# SEISMIC ANALYSES OF FHWA EXAMPLE 6 BRIDGE: PEER REVIEW

Group 4  
Haque, A. B. M. Tahidul  
Khusaibi, Hazim-Al  
Krishnappa, Nagarjun  
Kumar, Manish (mkumar2)  
Kumar, Manish (mkumar3)

# Damping

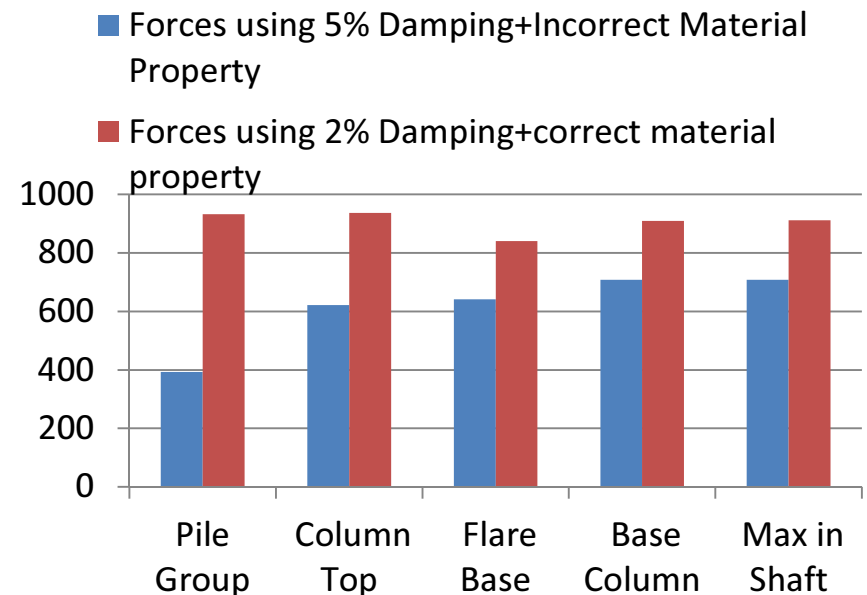
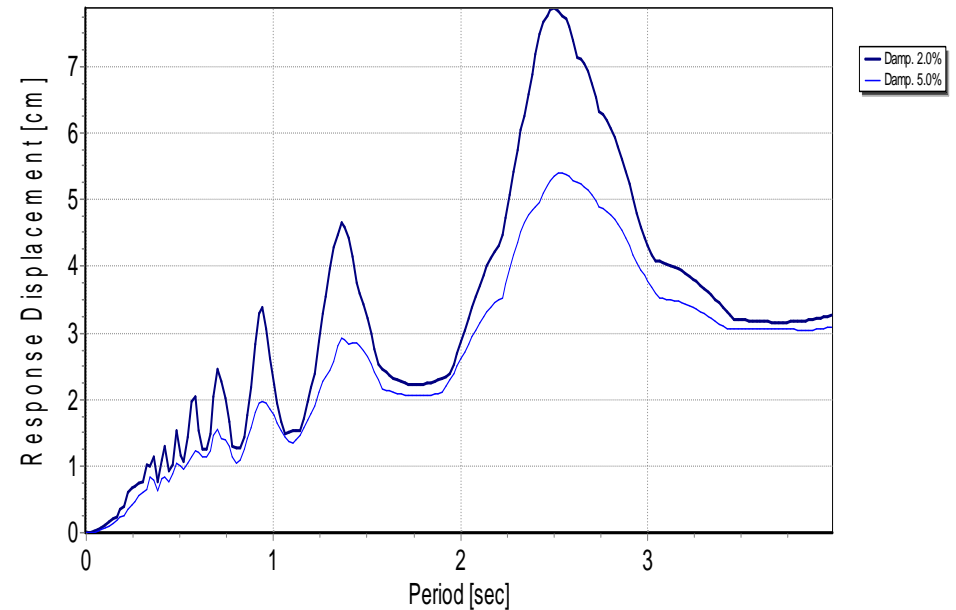
- 5% of critical have been used  
1.5-2% suggested for reinforced concrete bridge(Villaverde 2007)
- Proportionality constant were calculated by assigning 5% damping to periods 1 secs and 0.1 sec in Nonlinear Dynamic Analysis
  - Default SAP2000 values were used
  - 2% damping should be assigned to 0.69 sec(1<sup>st</sup> Mode) and 0.68 sec(2<sup>nd</sup> Mode)

## Consultant Team's results

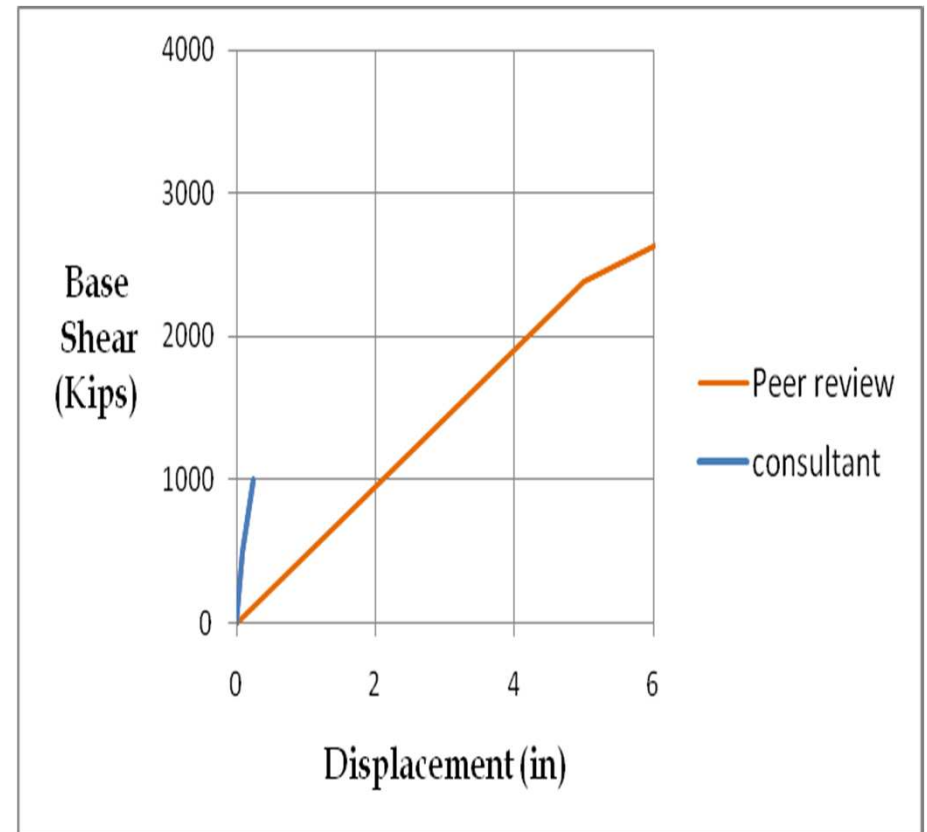
- Incorrect material type of the rebar steel - A992Fy50.
- Incorrect Values of material properties
- The column has 22 rebar(instead of 30). Thus incorrect estimation of the moment capacity of the columns.
- Model validation of hinge - there is no mention of P-M2-M3 hinge.
- Pushover Analysis was redone by Peer Review Team

Maximum Base shear = 1000 kips  
Displacement at yield = 0.24 in

# Application of Ground Motion Data

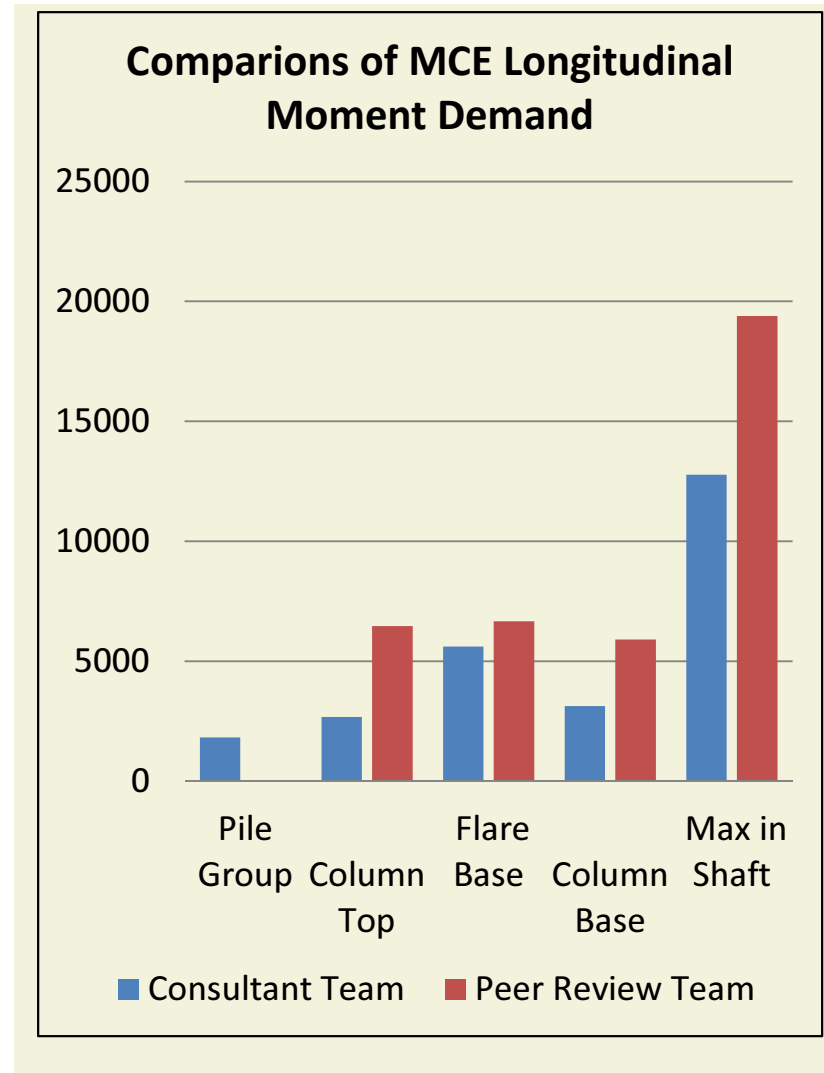
- 100-40% rule used for Nonlinear Dynamic Analysis  
Applicable only for modal analysis
- Application of two orthogonal components of ground motions simultaneously to calculate the response
- Results were underestimated

# Pushover Analysis

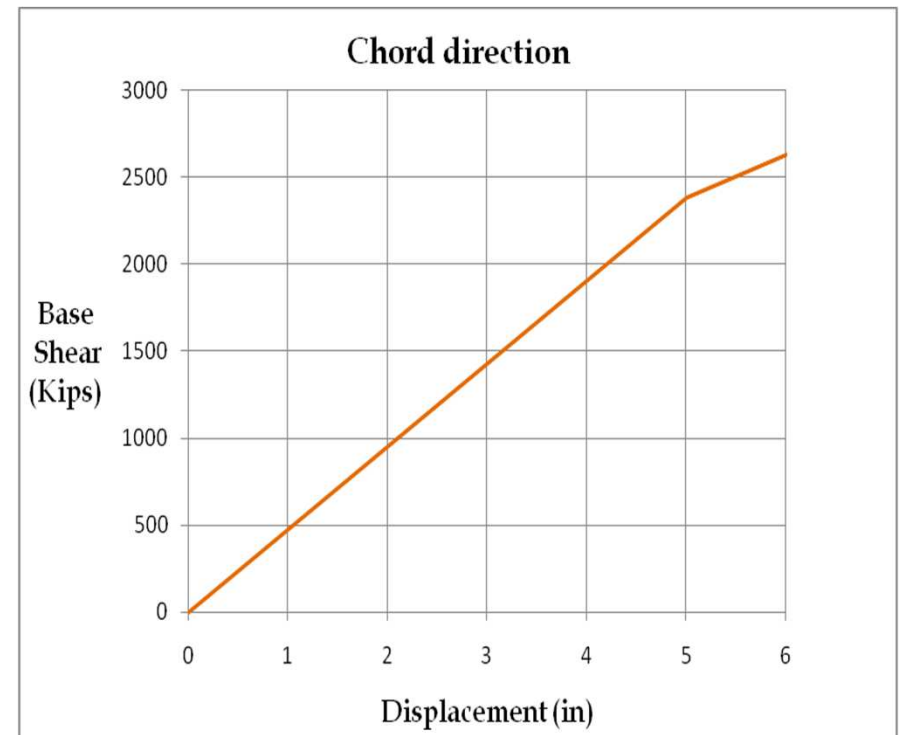
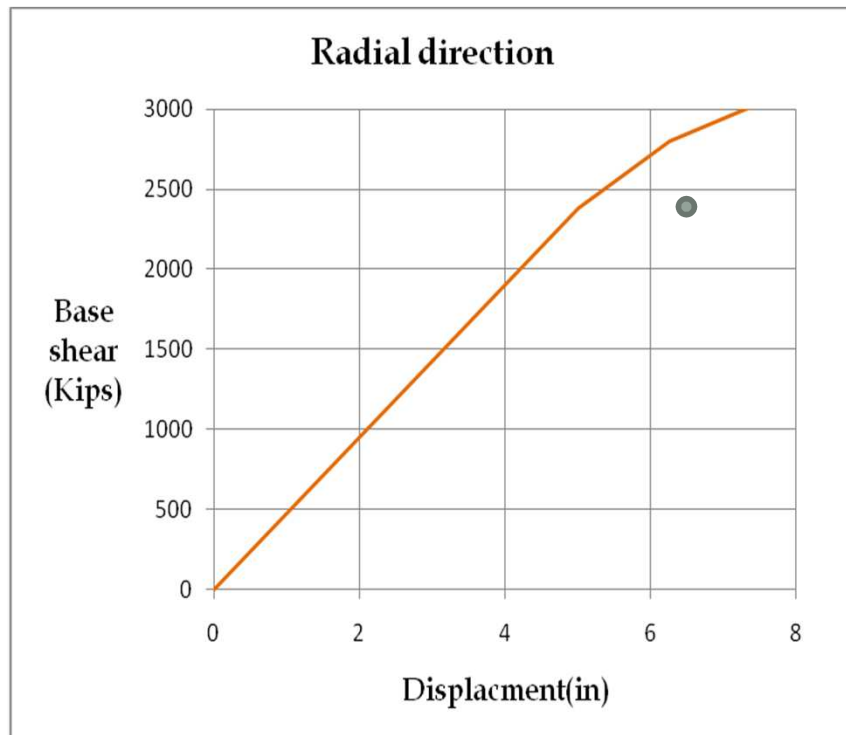
- No mention of detailed assumptions regarding cracked properties, lateral load pattern.
- Analysis done in single and unknown direction.

# Capacity Spectrum Analysis

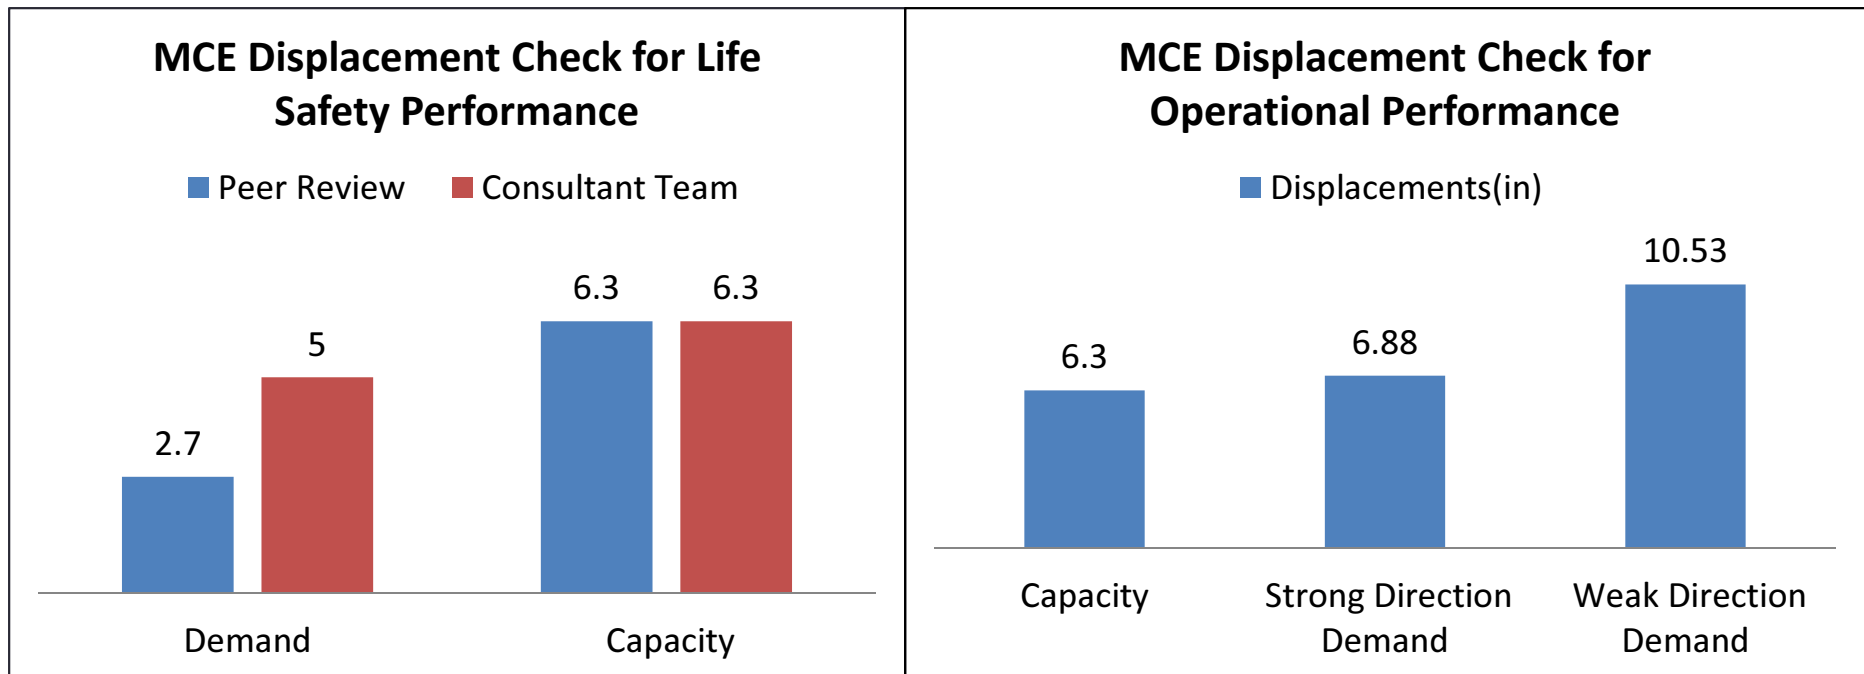
- Only capacity in strong direction was checked.
- Yield displacement from pushover was taken with nonseismic shear capacity.
- Capacity spectrum figure presented using SAP2000 is only applicable for buildings according to ATC-40.
- Operational performance was neglected for MCE.

# Nonlinear Dynamic Analysis

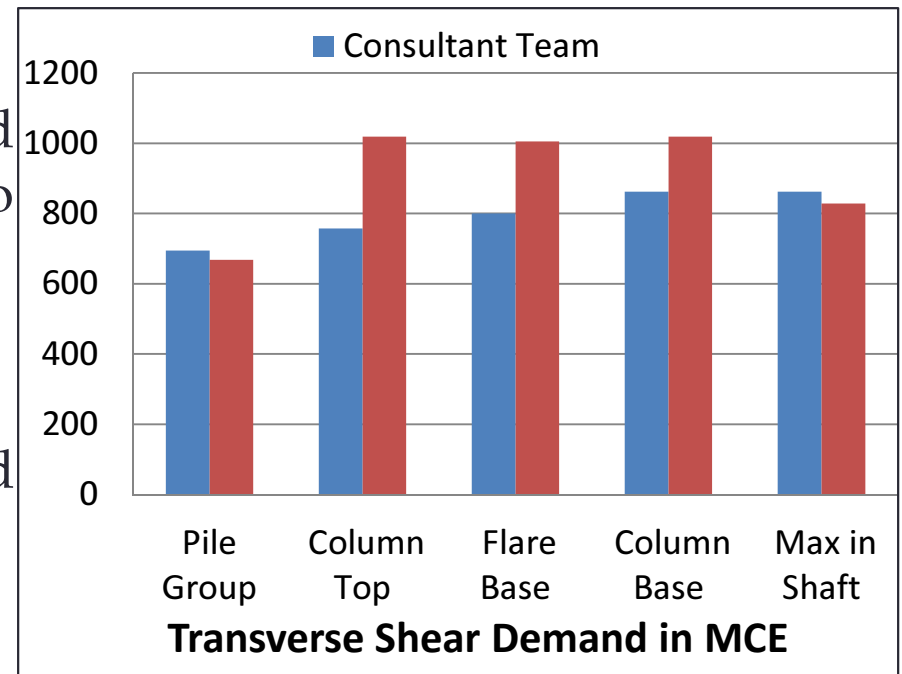
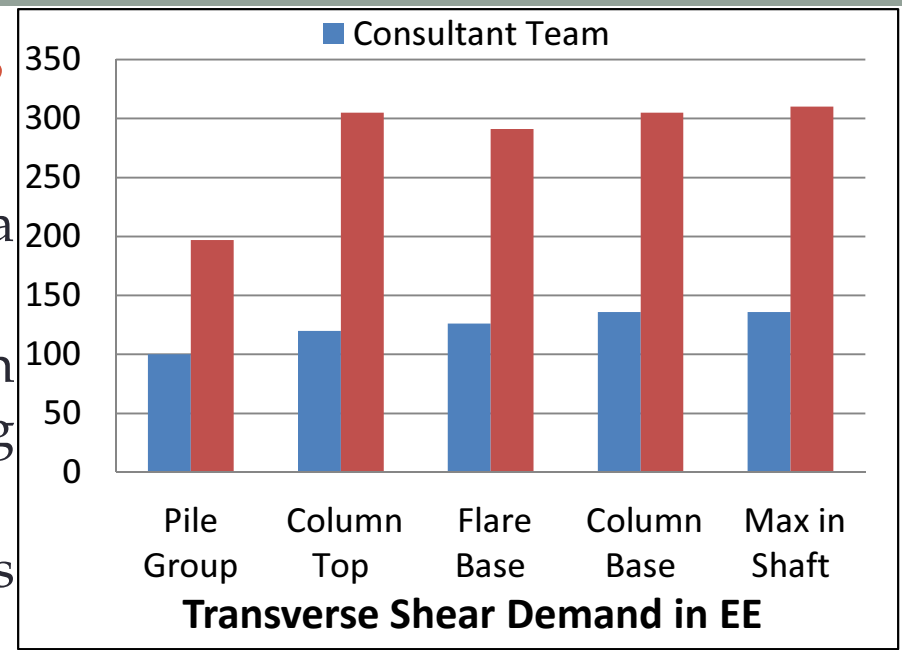
- Underestimated Seismic Hazard for EE
- Excessive value of damping for a reinforced concrete bridge structure.
- Only one component of ground motion used and response was calculated using 100-40% rule
- Wrong values of material properties for Nonlinear Hinges
- Nonlinear Analysis was performed twice to show sensitivity with respect to
  - Damping and Material Properties
  - Selection and Application of Ground Motion
- Demands were calculated for EE and MCE

- Correct Seismic Hazard for EE should be used
- Calculations should be done using 2% damping
- Nonlinear Hinges should be defined appropriately using correct material properties
- Ground motions should be selected from PEER ground motion database having strong and weak components
- Nonlinear Dynamic Analysis with application of strong and weak components of ground motion simultaneously
- Capacity of bridge should be checked in all the directions, for different performance criteria
